**Re: Sevilla @ Andalucia
Engineer Certification For Release of SIA/Financial Guarantee
Engineer's Stamp Date 4/18/2015 (F11/D015C)**

RE: Sevilla @ Andalucia - (File: F11D015C)
Revised Grading and Drainage Plans, Engineer's Stamp Date 2-19-2015

RE: **Sevilla @ Andalucia - (File: F11D015C)**
Drainage Management Plan, Engineer's Stamp Date 1-19-2015
Grading and Drainage Plans, Engineer's Stamp Date 1-19-2015

Re: Response to Comments
Drainage Master Plan for Sevilla @ Andalucia

NORTH SWALE

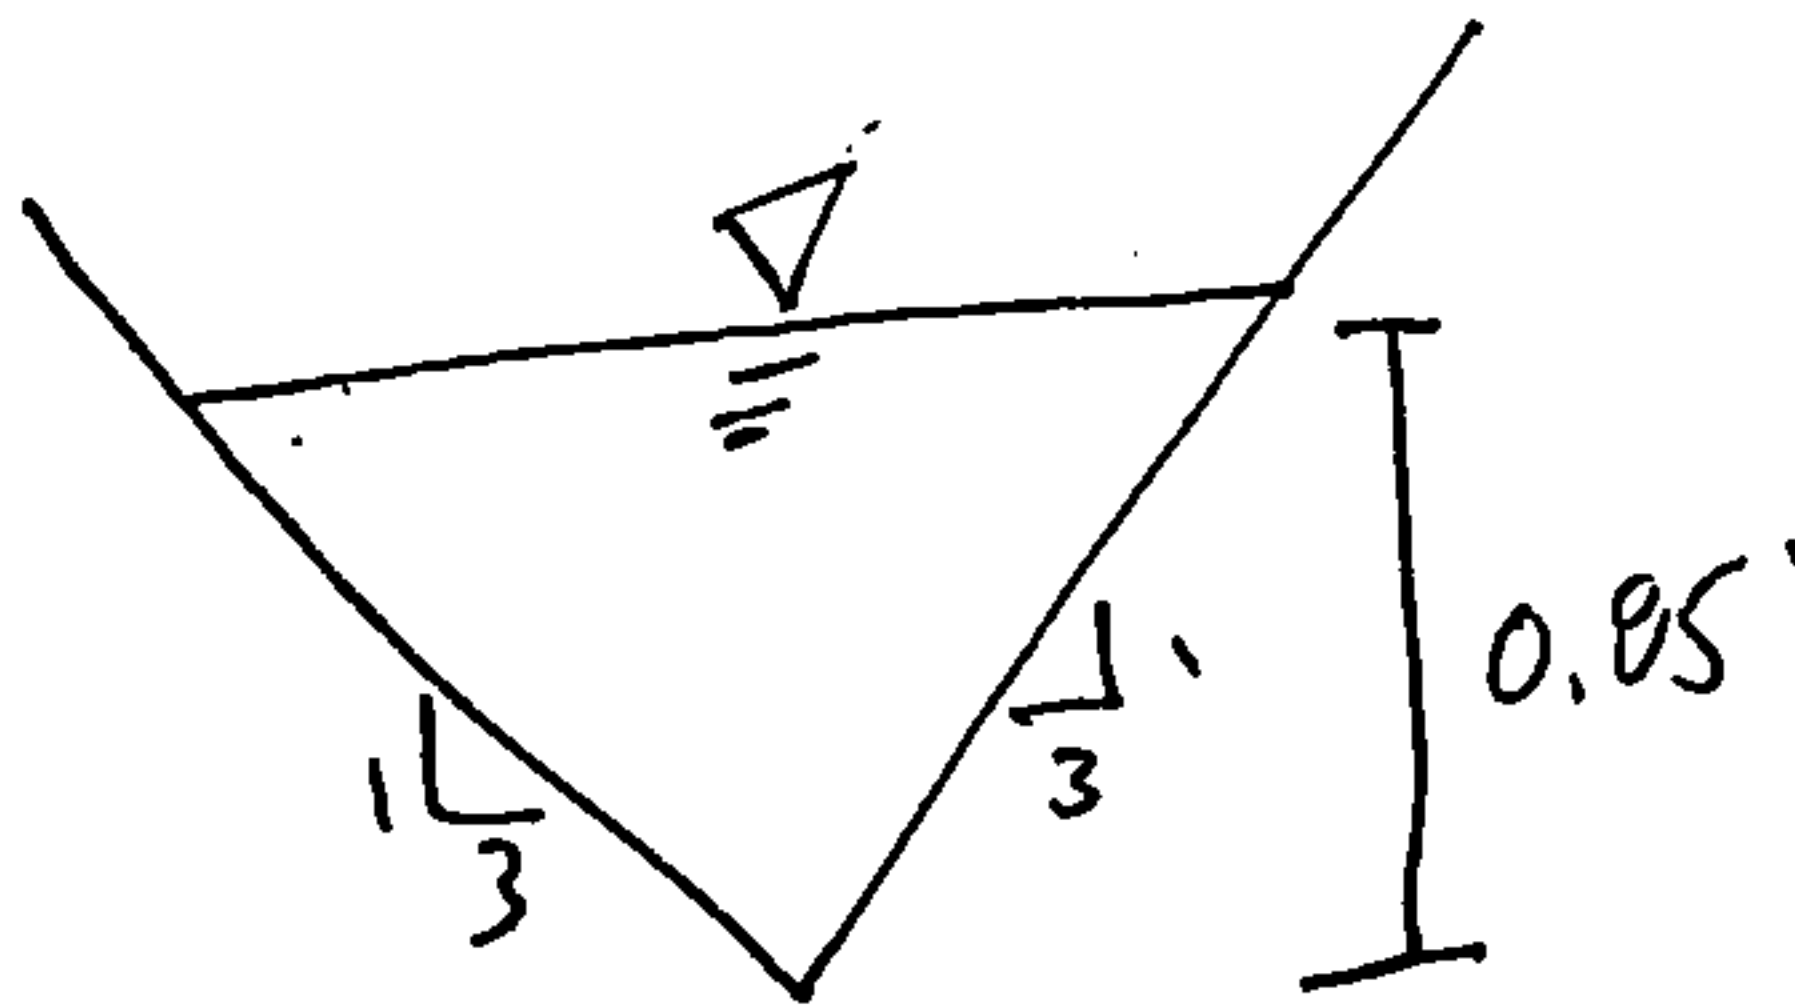
✓ 18. Show on the Grading Plan the earth lined swales that Basins B and F and K drain to as indicated in the report.

Basin F ($A=0.9$ acres, $Q=2.7$ cfs) discharges east through the back of the lots via turn blocks where the flows combine with Basin K ($A=0.2$ acres, $Q=0.5$ cfs). The combined flow of $Q=3.2$ cfs is conveyed by a cobble-lined swale to ultimately enter the San Antonio Arroyo at a single discharge point. Basin B ($A=1.2$ acres, $Q=3.7$ cfs) discharges east through the back of the lots via turn blocks and is conveyed by an earth-lined swale to ultimately enter the San Antonio Arroyo at a single discharge point. Please see Appendix D-Swale Analysis as well as Exhibit 6-Grading Plan for additional swale analysis.
